Ref: 7901/pja

29th July 2025

Re: McDonald's, Bridge Retail Park, Wokingham - Acoustic Impact of proposed relocated delivery door

Figure 1 showing existing 1st flr fire escape door with existing ground floor one directly below facing into a steep bank

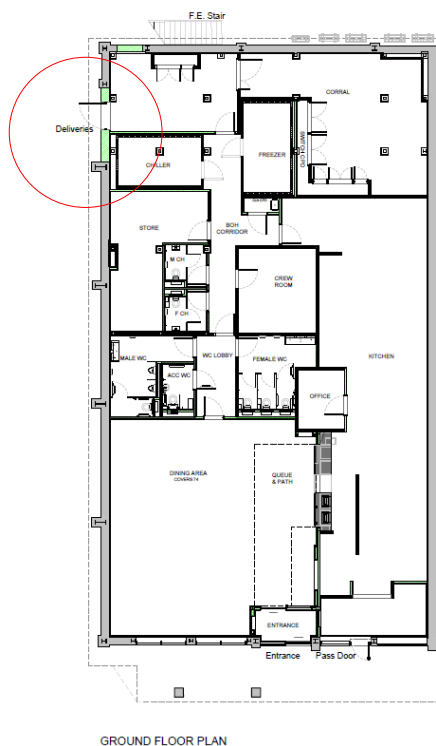
This door faces into a steep bank rising up to a footpath and the railway line. The photograph below shows the 1st floor fire escape door, directly above the existing ground floor one;

It is proposed that this doorway, for operational reasons, is relocated to the NW corner of the building as shown in proposed drg No. 8671-SA-P006F, an extract is shown below;

There is no view of the existing ground floor Delivery door and neither will there be any for the proposed door in the NW façade, due to the substantial screening offered by the banking around the site, from the neighbours on Oakley Drive.

The location of the proposed new Delivery door can be expected not to create any adverse impacts, for the neighbours.
